AS BUILT VARIATIONS

Project Name
ALTERATIONS & ADDITIONS
72 BOURKE STREET
TAMWORTH NSW 2340

Status: AS BUILT Scale: 1:200, 1:66.67 @ A

Drawing Title
SITE PLAN

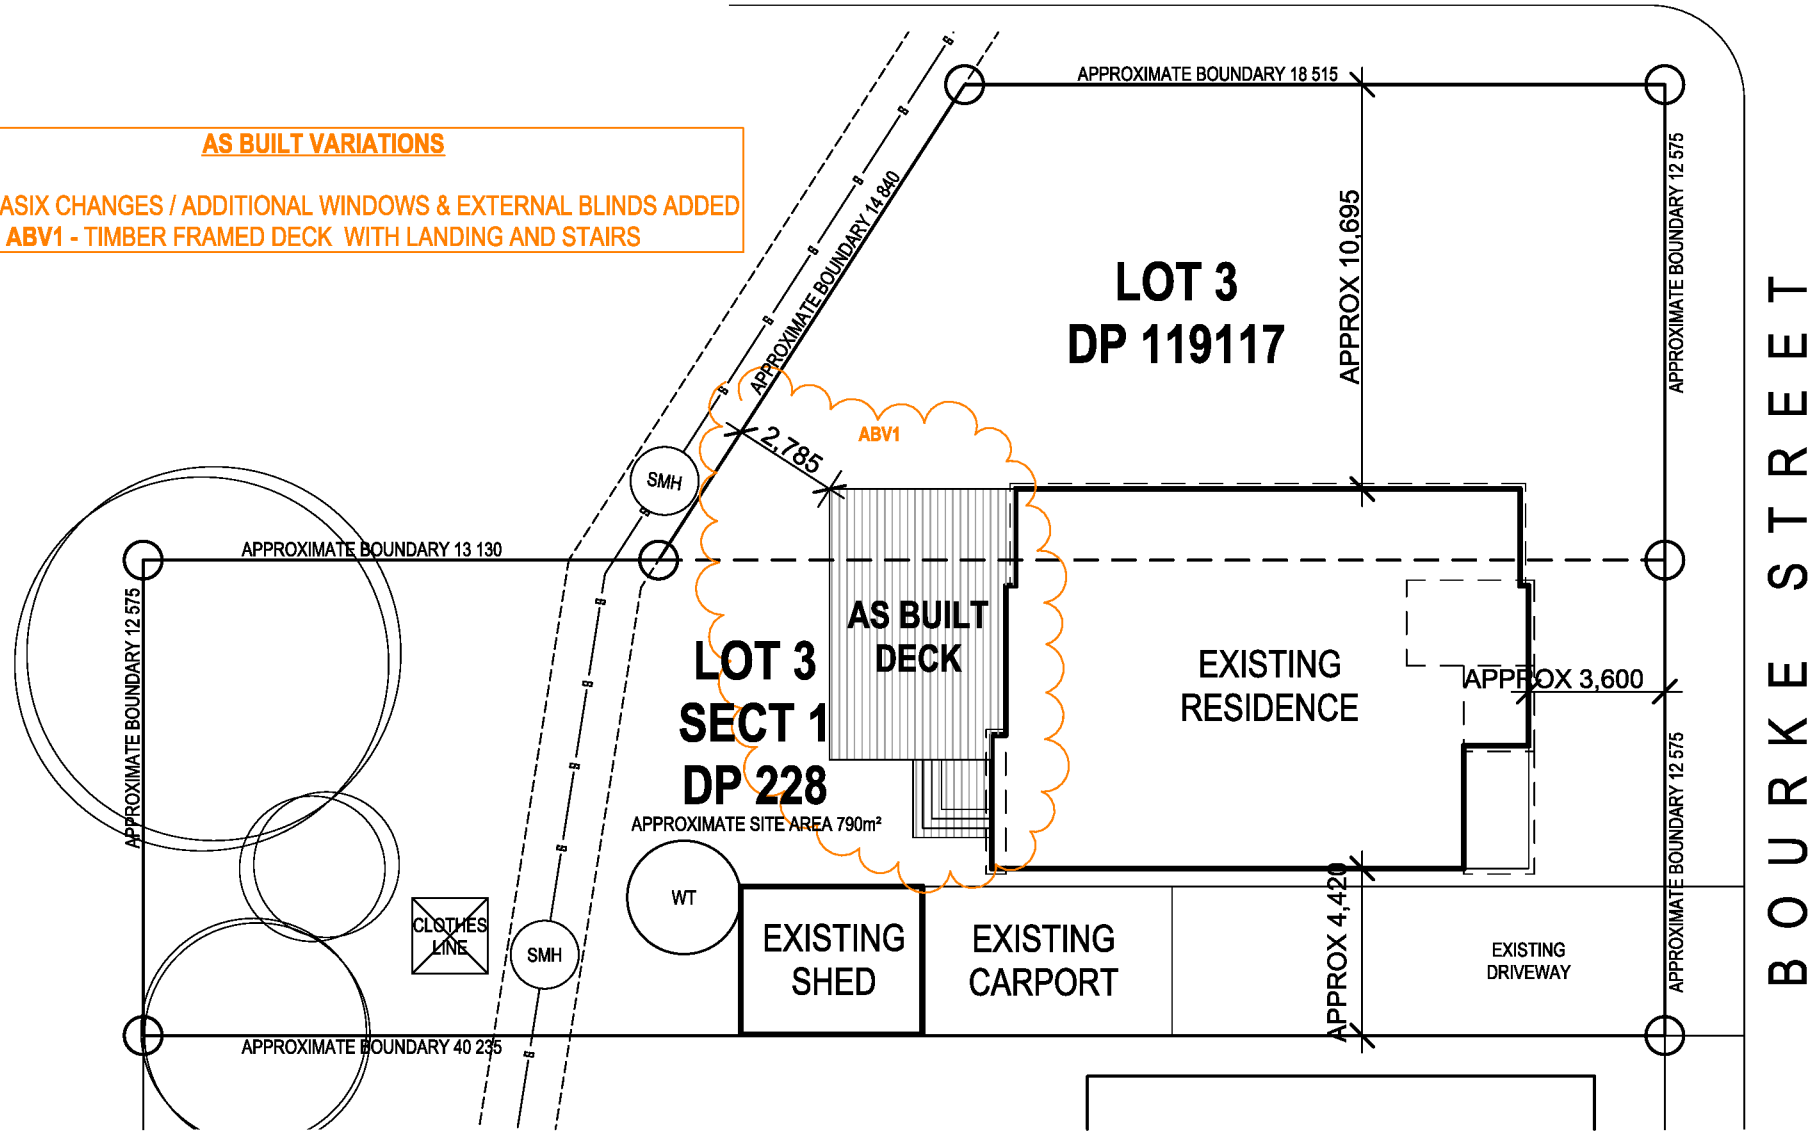
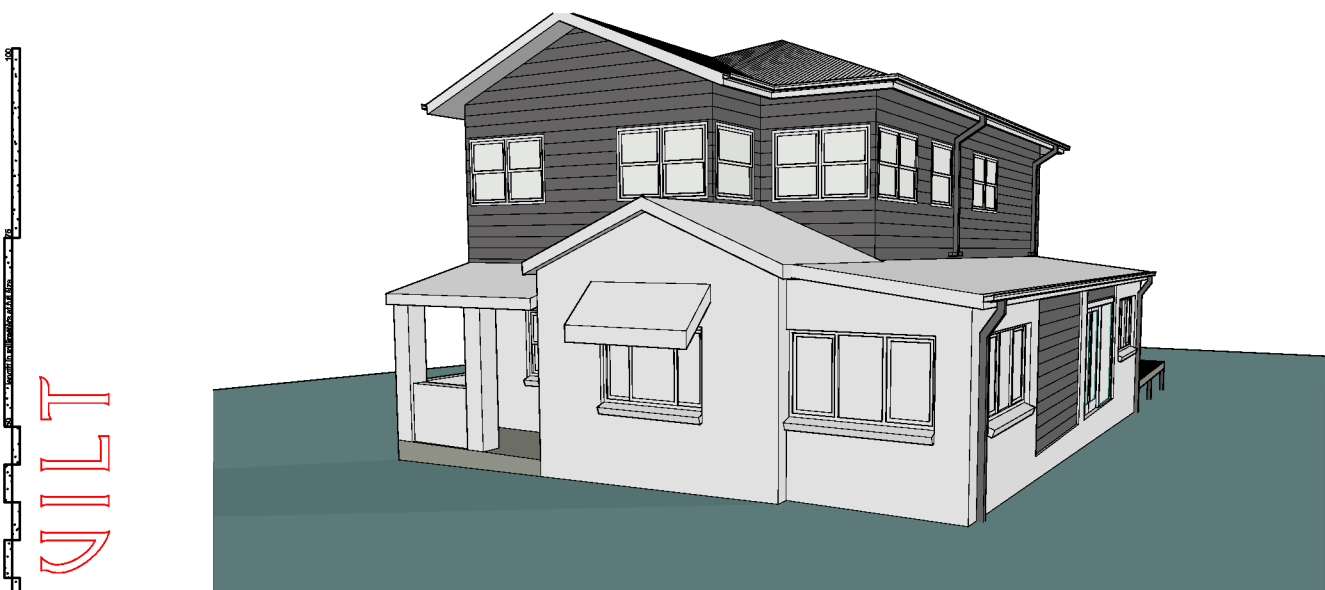
ABV0 - BASIX CHANGES / ADDITIONAL WINDOWS & EXTERNAL BLINDS ADDED

ABV1 - TIMBER FRAMED DECK WITH LANDING AND STAIRS

WESTERN ELEVATION

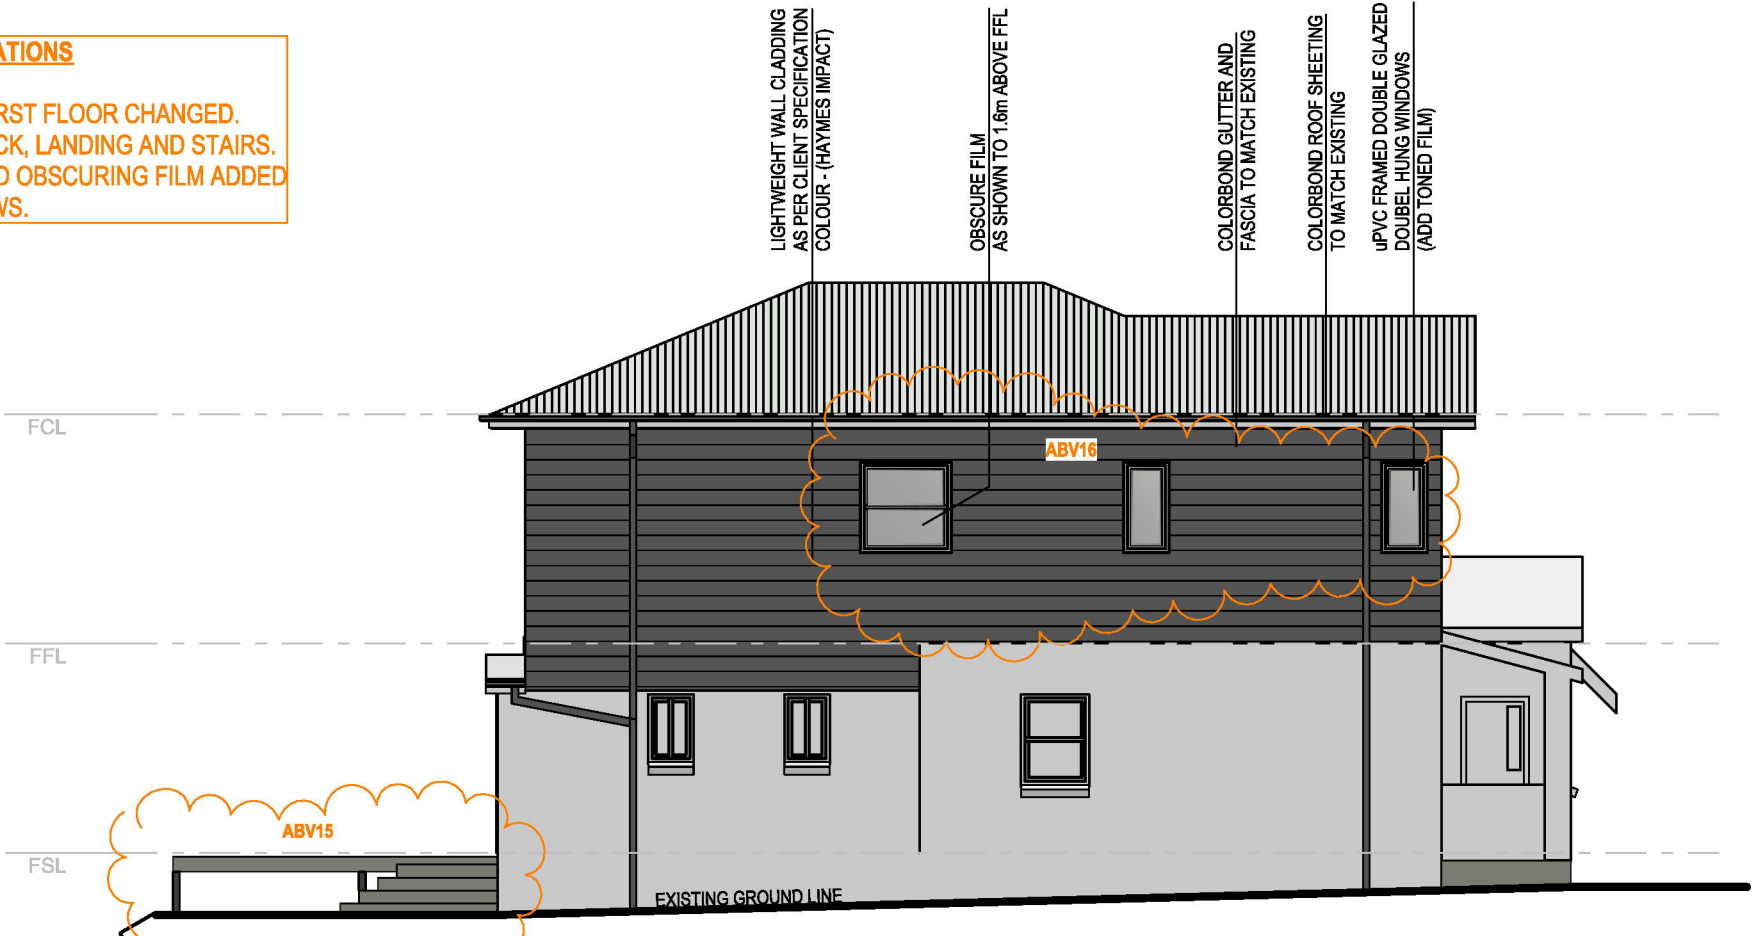
ABV14 - CEILING HEIGHT OF FIRST FLOOR CHANGED.
ABV15 - NEW TIMBER FRAMED DECK, LANDING AND STAIRS.
ABV16 - NEW WINDOWS ADDED AND OBSCURING FILM ADDED TO WINDOWS.

EASTERN ELEVATION

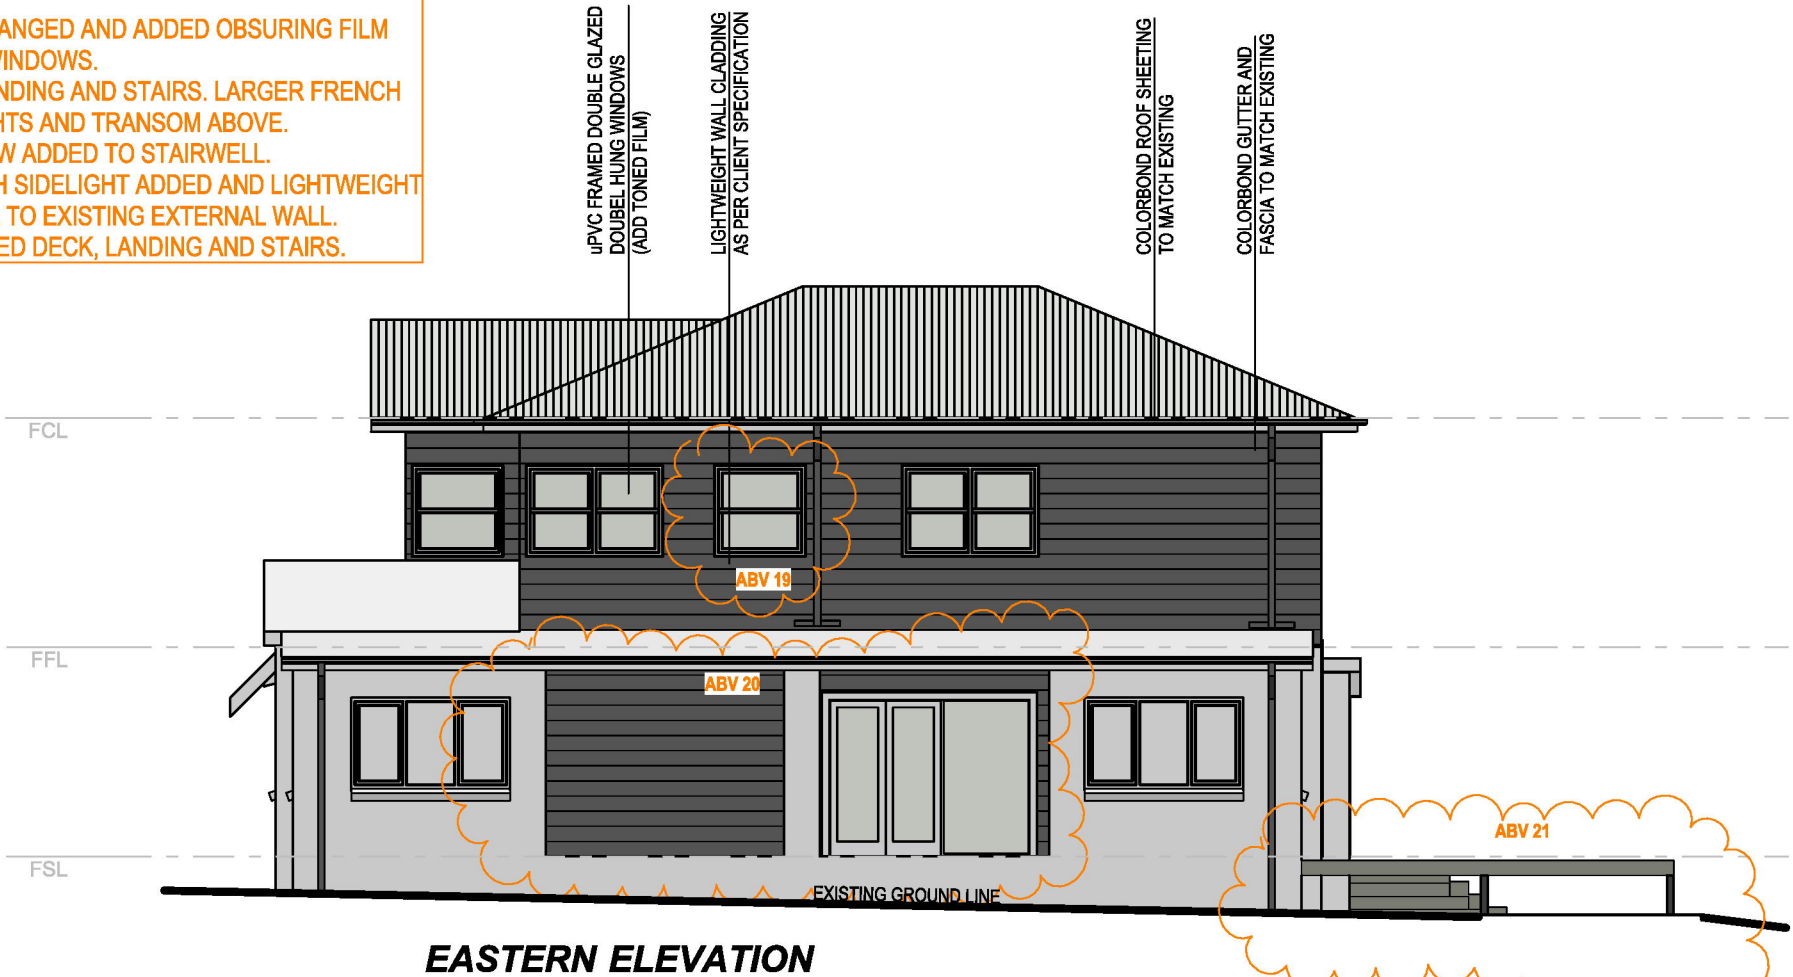
- ABV17** - WINDOW LOCATION CHANGED AND ADDED OBSURING FILM TO WINDOWS.
- ABV18** - NEW FRAMED DECK , LANDING AND STAIRS. LARGER FRENCH DOORS WITH SIDELIGHTS AND TRANSOM ABOVE.
- ABV19** - NEW WINDOW ADDED TO STAIRWELL.
- ABV20** - NEW FRENCH DOORS WITH SIDELIGHT ADDED AND LIGHTWEIGHT CLAD FRAMED WALL INFILL TO EXISTING EXTERNAL WALL.
- ABV21** - NEW TIMBER FRAMED DECK, LANDING AND STAIRS.

Drawing Title
SUN STUDY

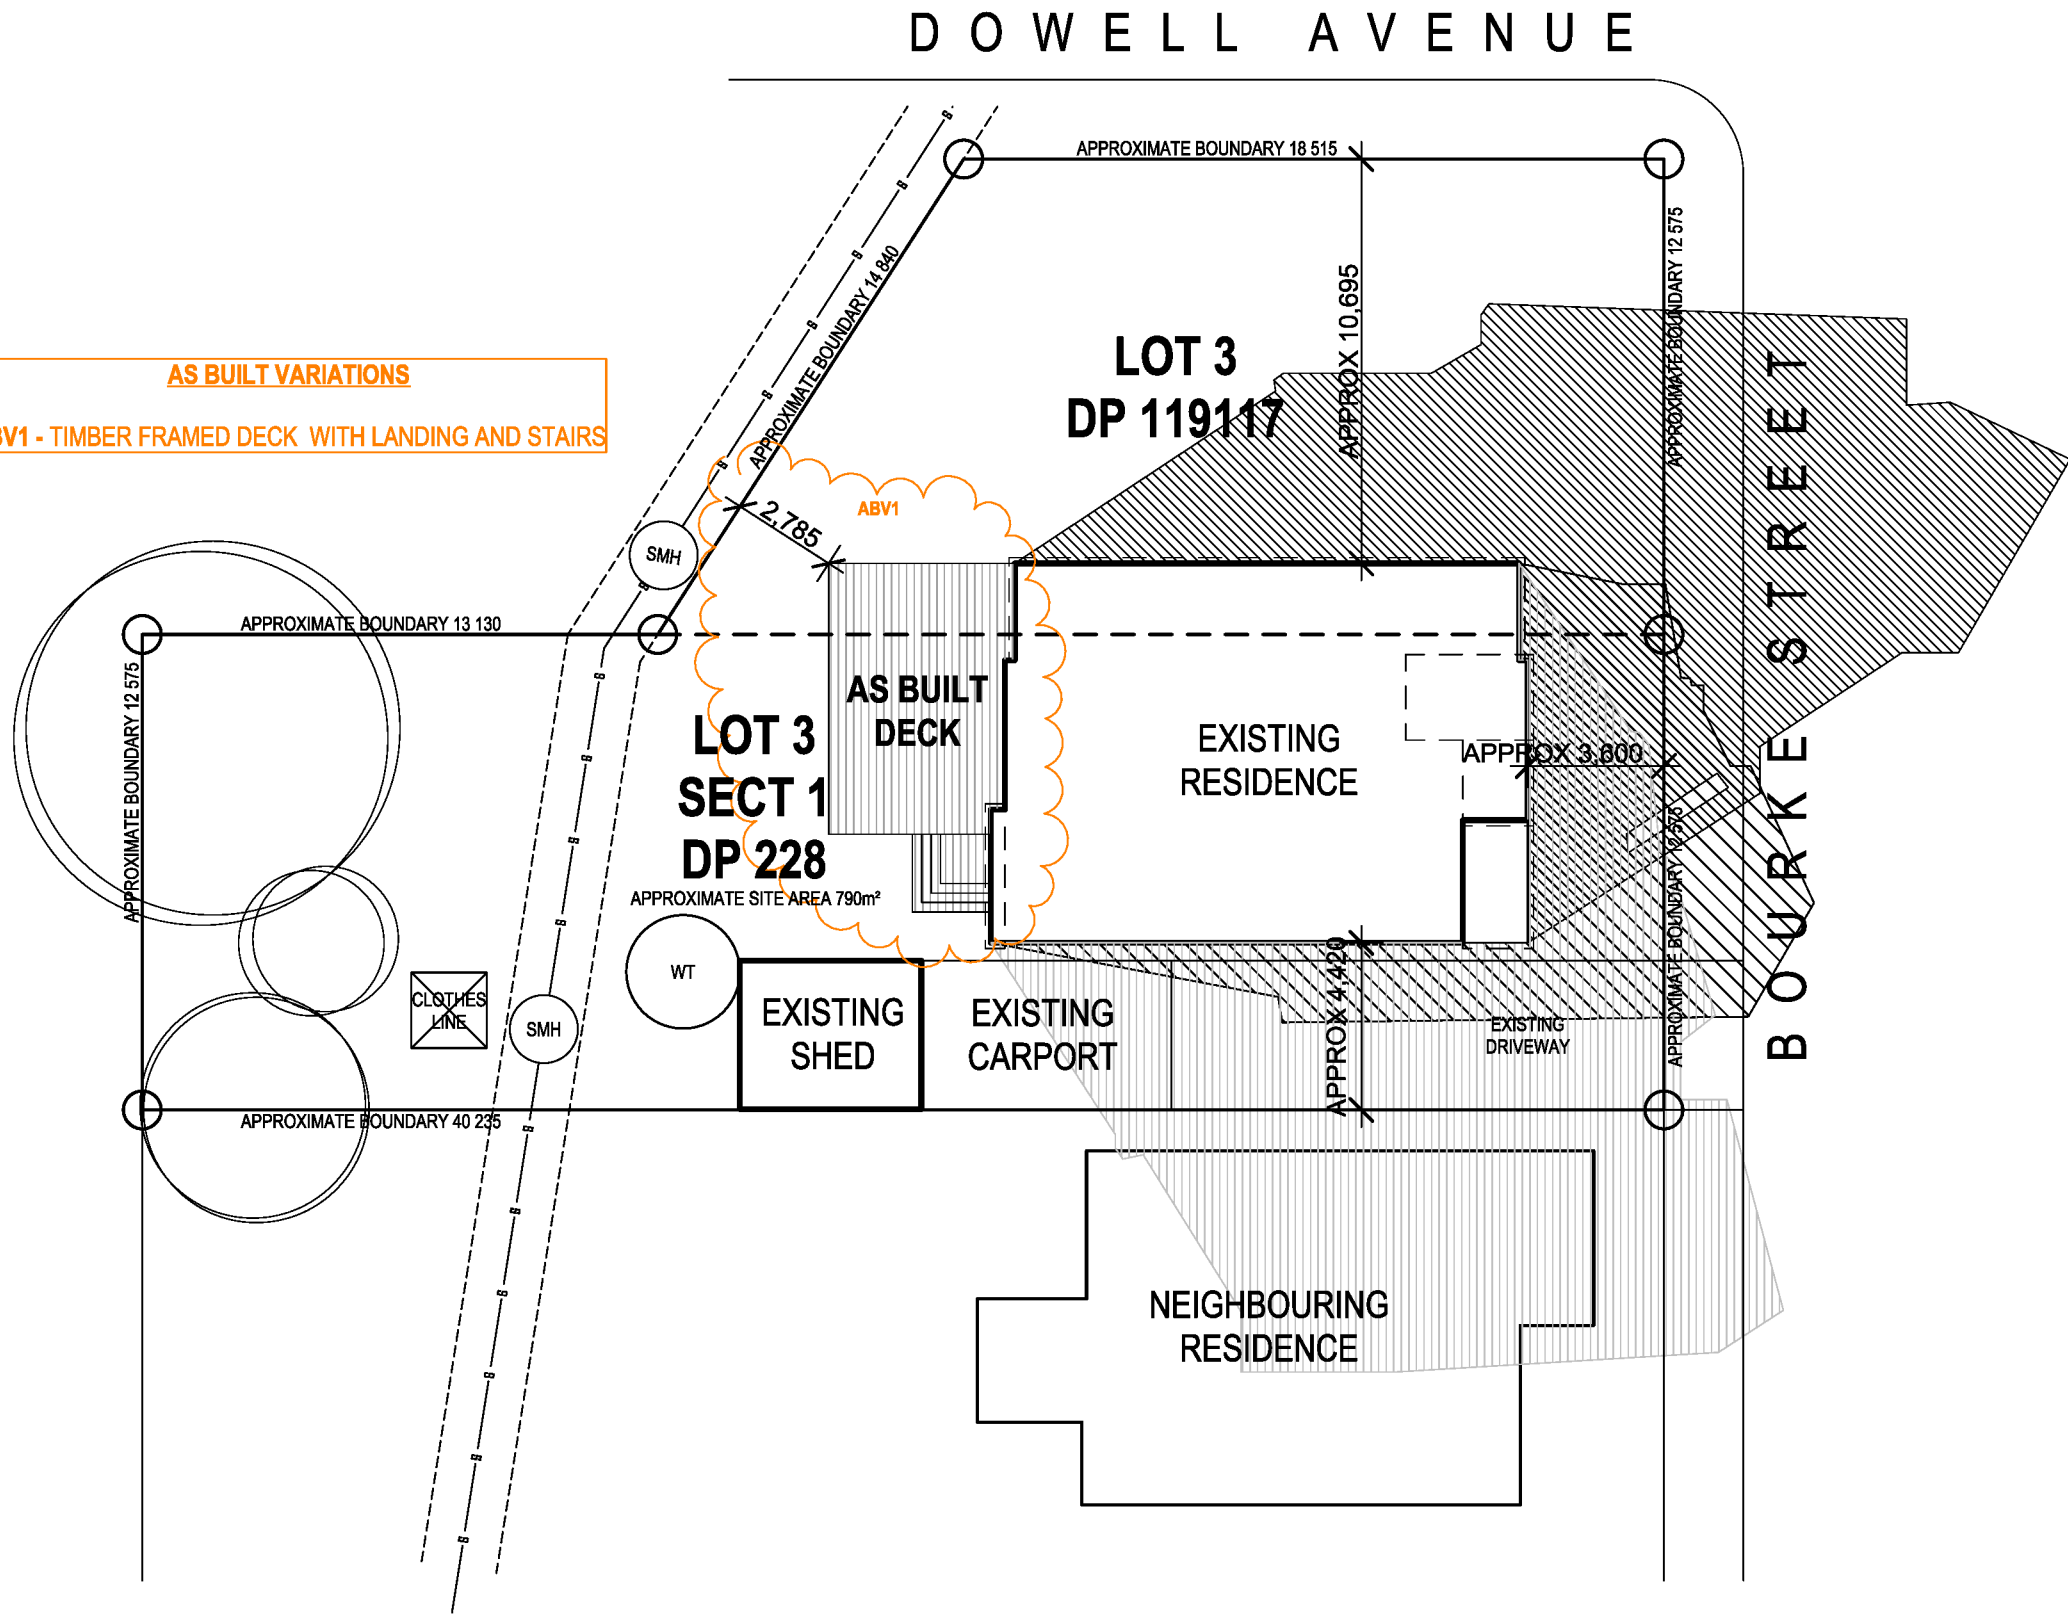
AS BUILT VARIATIONS
ABV1 - TIMBER FRAMED DECK WITH LANDING AND STAIRS
